# UNITED STATES PATENT AND TRADEMARK OFFICE

APPLICATION NO.	FILING DATE	FIRST NAMED INVENTOR	ATTORNEY DOCKET NO.	CONFIRMATION NO.
10/774,194	02/05/2004	Yi-Chiau Huang	AMAT/8461/CMP/ECP/RKK	6951
44257	7590	12/20/2005	EXAMINER	
PATTERSON & SHERIDAN, LLP 3040 POST OAK BOULEVARD, SUITE 1500 HOUSTON, TX 77056			JEFFERSON, QUOVAUNDA	
			ART UNIT	PAPER NUMBER
			2823

**Office Action Summary**

## **DETAILED ACTION**

Fig. 1

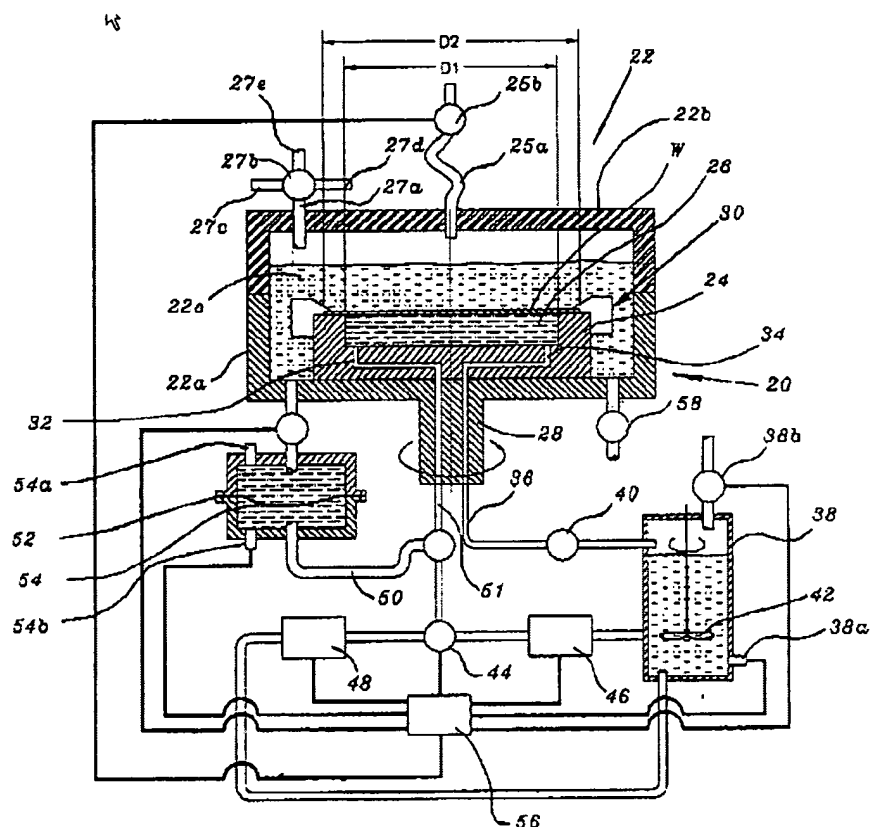
Claims 15 and 16 are rejected under 35 U.S.C. 103(a) as being unpatentable over Uzoh as applied to claim 8 above, and further in view of Ivanov, US Patent Application 2004/0097071. Please see figure 1 directly below paragraph.

Regarding claim 15, Uzoh fails to teach the method of claim 8, but further comprising controlling a temperature of a rinsing fluid to remain at a constant temperature. Ivanov teaches controlling a temperature of a rinsing fluid to remain at a constant temperature 46. It would have been obvious to one skilled in the art to combine

Regarding claim 16, Ivanov further teaches the method of claim 15, further comprising reading a temperature of a heated solution with a thermocouple **38a** and controlling a heater positioned in communication with the rinsing solution in accordance with a temperature indicated by the thermocouple **38a**.

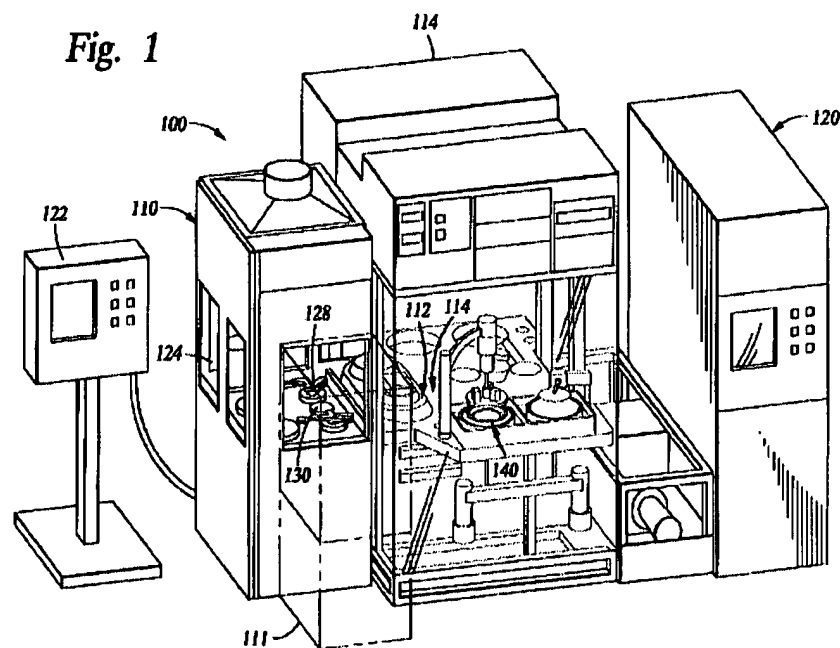
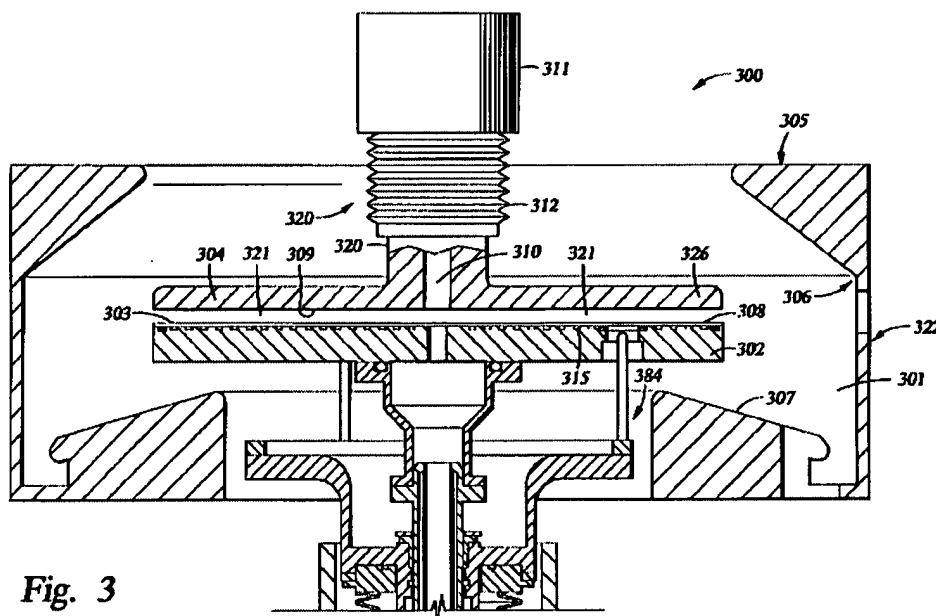
Claim 17 is rejected under 35 U.S.C. 103(a) as being unpatentable over Lubomirsky, US Patent Application Publication 2003/0131494 and Uzoh et al, US Patent 6,692,588. See Lubomirsky's Figures 1 and 3 directly below.

Lubomirsky teaches an apparatus for processing a substrate, comprising of a plating cell positioned on a processing platform, the plating cell being configured to plate a conductive layer onto the substrate, **figure 1-100**, a rinsing cell **figure 1-112** positioned on the processing platform, the rinsing cell comprising of a substrate support member configured to support the substrate for processing, **figure 3-302**, and a substrate annealing station positioned in communication with the processing platform, **figure 1-111**. Lubomirsky fails to teach a radiant fluid heating assembly connected to the rinsing cell and disposed to provide radiant heat directly to heat the substrate.

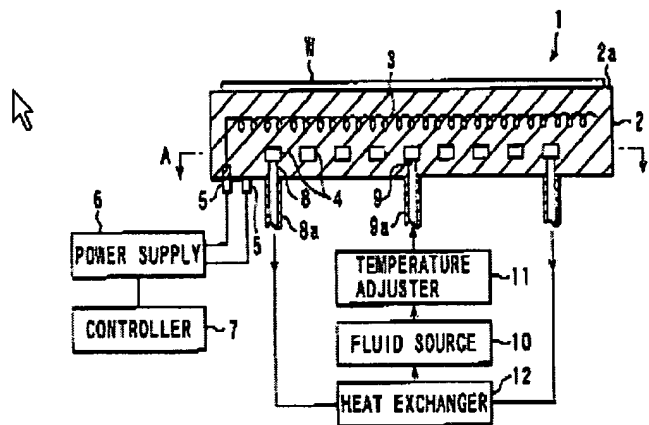
Claim 20 rejected under 35 U.S.C. 103(a) as being possibly being unpatentable over Lubomirsky and Uzoh et al as applied to claim 17 above, and further in view of Narushima, US Patent 6,951,587.

Regarding claim 20, Lubomirsky and Uzoh fail to teach the apparatus of claim [17], wherein the radiant heating assembly further comprises a temperature monitoring device, the temperature monitoring device being configured to monitor the temperature of the substrate and control application of electrical power to the radiant heating assembly. Narushima teaches a radiant heating assembly 1 further comprises a temperature monitoring device 7, the temperature monitoring device being configured to monitor the temperature of the substrate and control application of electrical power to the radiant heating assembly. It would have been obvious to one skilled in the art to
